Monticello Nuclear Generating Plant

License Amendment Request Dated July 26, 1989

Proposed Changes Marked Up on Existing
Technical Specification Pages

REVISED TECHNICAL SPECIFICATION PAGES

Figure 4 Flow-Dependent MCPR Limits, MCPR(F)

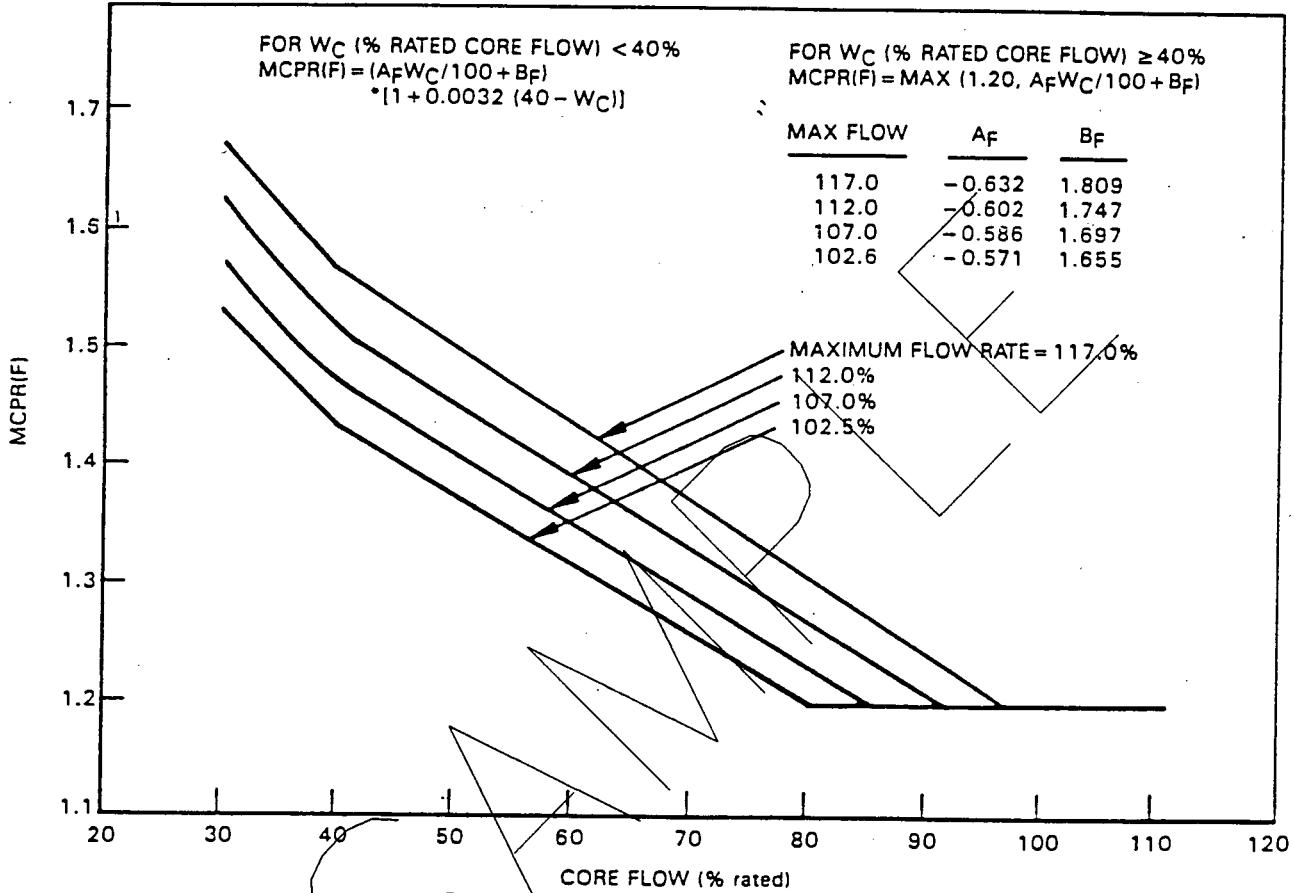
1.30 x K_p (K_p from Figure 3) or the $MCPR_f$ from Figure 4.
